802.11aa LB164 – Status of ‘Interworking with 802.1Qat’ comments

Date: 2010-07-15

Alternate Proposal-B -- MSRP Handling at AP/DMN (to Talker/Listener)

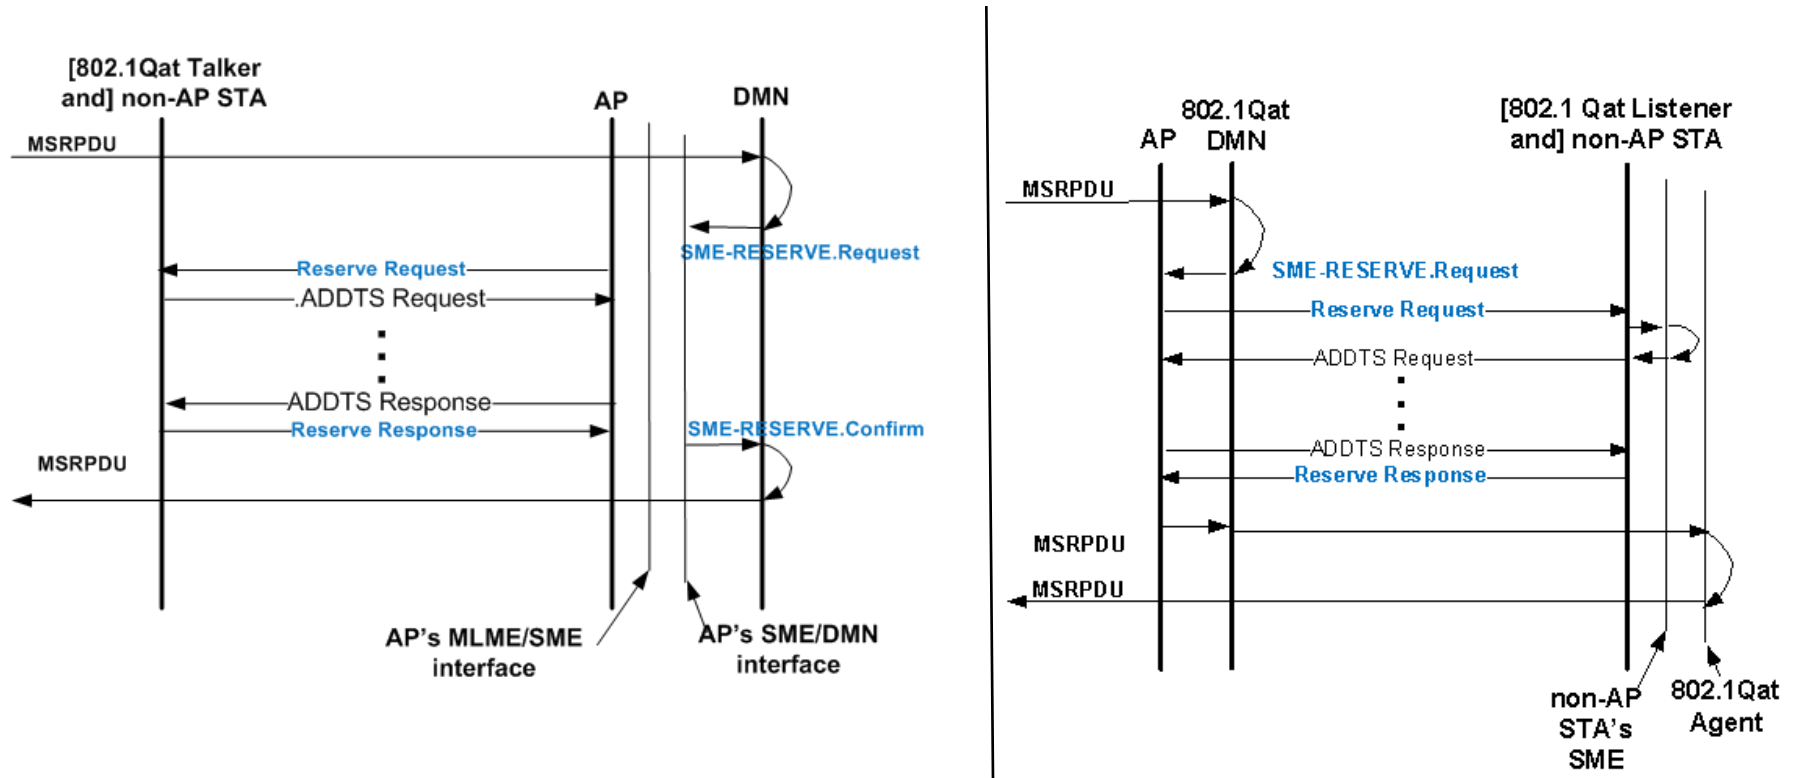
1. Need a new "Reserve" management frame between AP to STA
2. STA at Talker end does not have to parse SRP messages; no additional processing in 802.11
3. No synchronization issues
4. Addresses all issues listed in slide-10

MSRPDU Reserve: Proposal 2.a

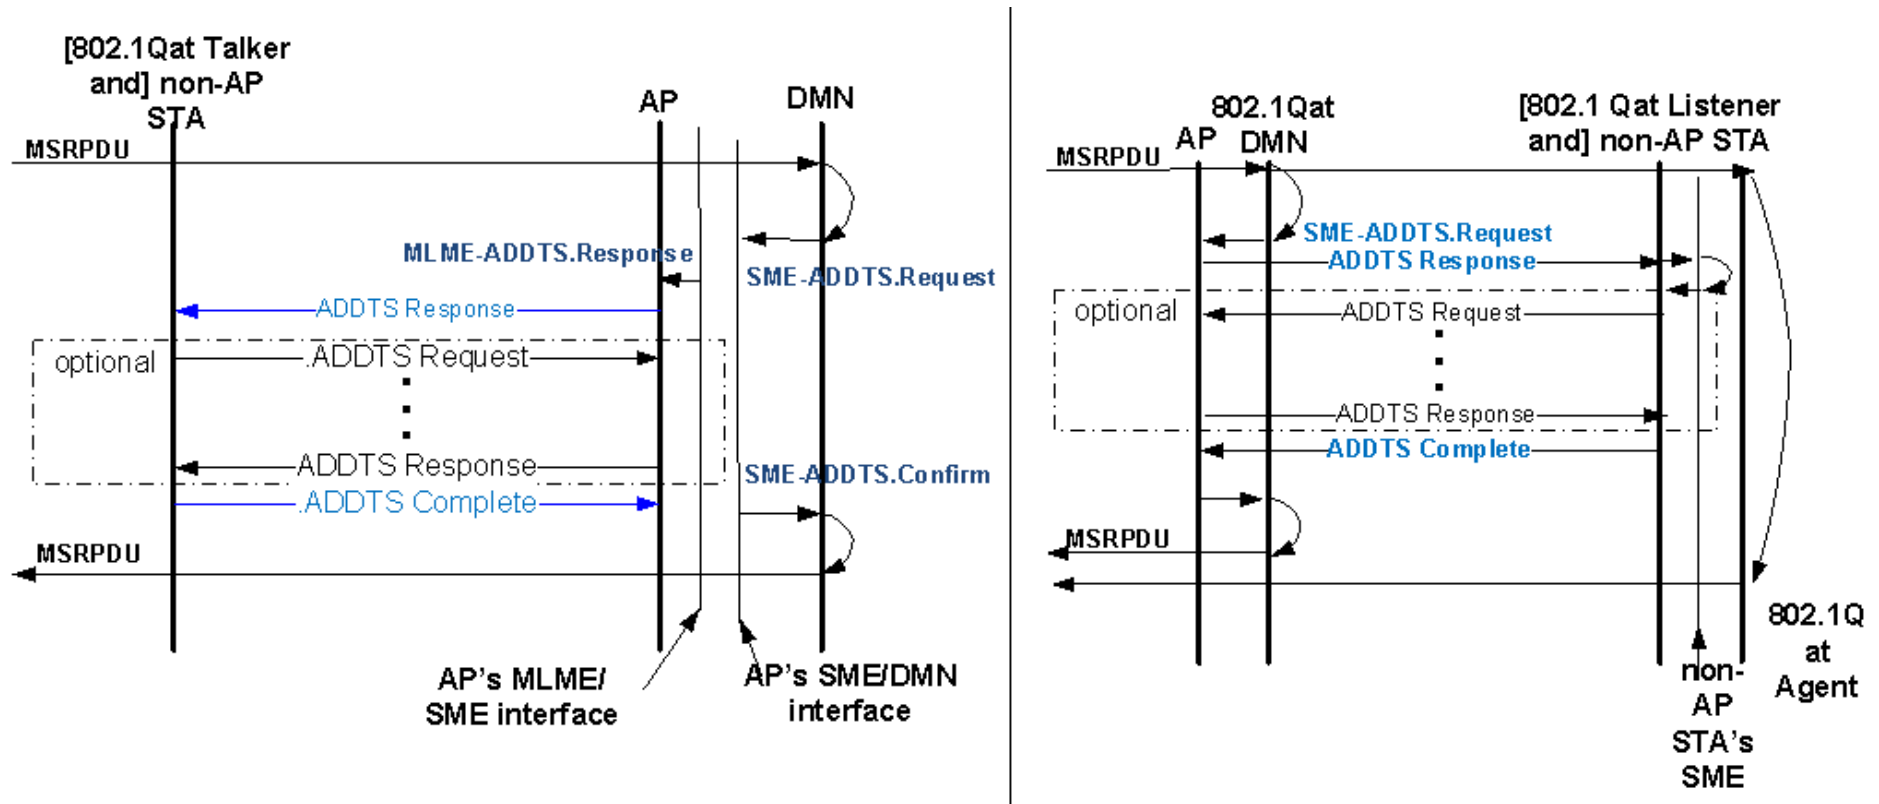
1. First ADDTS Response is autonomous
2. ADDTS Request and ADDTS Response have a new IE – MSR Stream ID (64 bits)
3. ADDTS Complete is same as Reserve Response and just has MSR Stream ID and Status IEs in it.

MSRPDU Reserve: Proposal 2.b

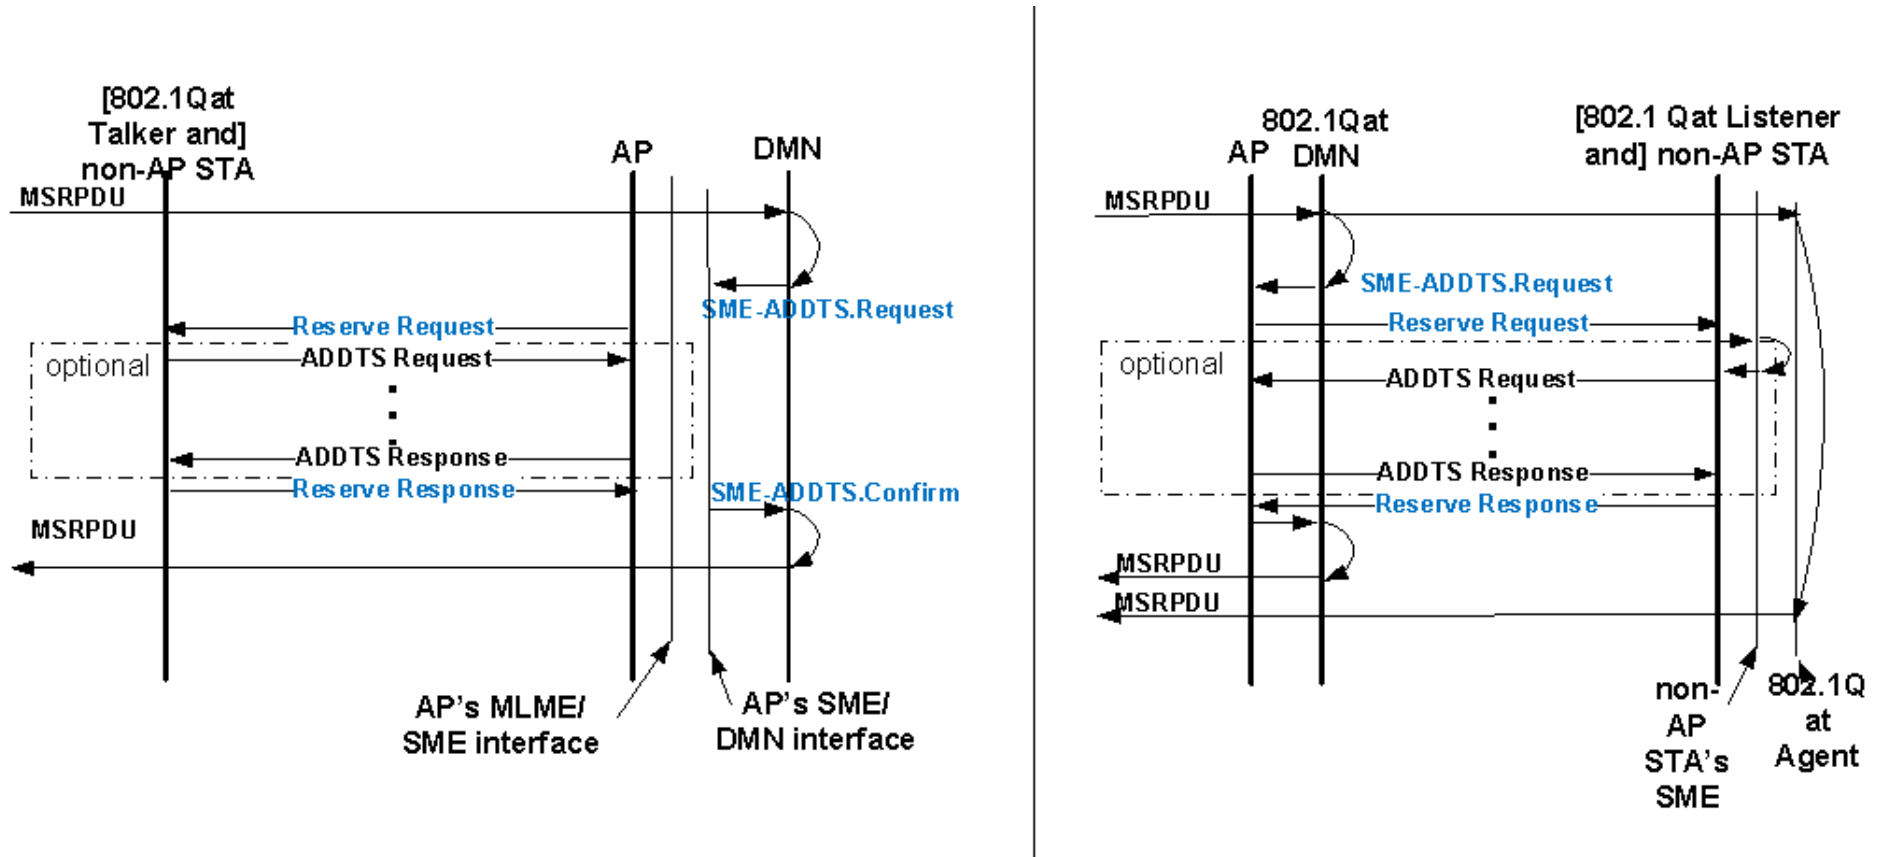
1. Reserve Request has a TSPEC element in it.
2. ADDTS Request and ADDTS Response have a new IE – MSR Stream ID (64 bits)

MSRPDU Query

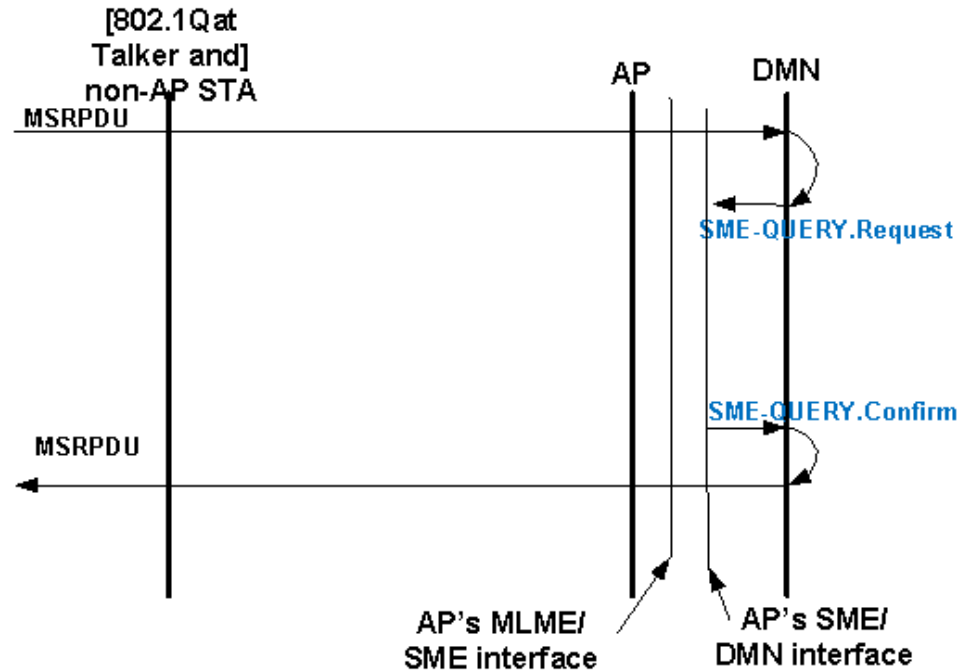
1. MSRPDU Querying for resource availability forwarded to the AP from the non-AP STA
2. The DMN at the AP translates the MSRPDU into equivalent 802.11 TSPEC and invokes the SME-QUERY.Request
3. The SME at the AP responds back to the DMN at the AP using the SME-QUERY.confirm primitive
4. There are no 802.11 messages over the air to complete this protocol
